ACCESS REPORT

Proposed residential development
80-82 Showground Rd, Gosford NSW

Prepared for
DTA Architects

Reference No.
24303-DA

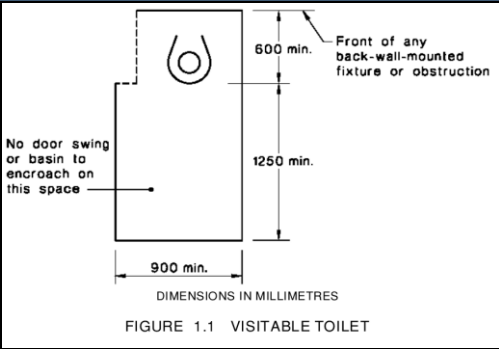
Class C Requirements	Clause No.	Commentary
DRAWINGS		
Provision of drawings showing the housing unit in its pre-adaptation and post-adaptation stages.	2.3	<p>The subject developments propose 26 residential units of which 4 units shall be adaptable (~15% of total units).</p> <p>Pre & post adaptable plans have not been provided at this stage, however the units proposed to be adaptable have been numbered and the design shows compliance capability.</p> <p>The finer design details shall be reviewed at the detailed design phase.</p>
SITING		
A continuous accessible path of travel from street frontage and vehicle parking to entry complying with AS 1428.1.	3.3.2	Compliance with Section 2.0 of this report will result in compliance this clause.
LETTERBOXES		
Letterboxes to be located on a hard standing area connected to an accessible pathway.	3.8	Letterboxes have been suitably detailed in accordance with this clause.
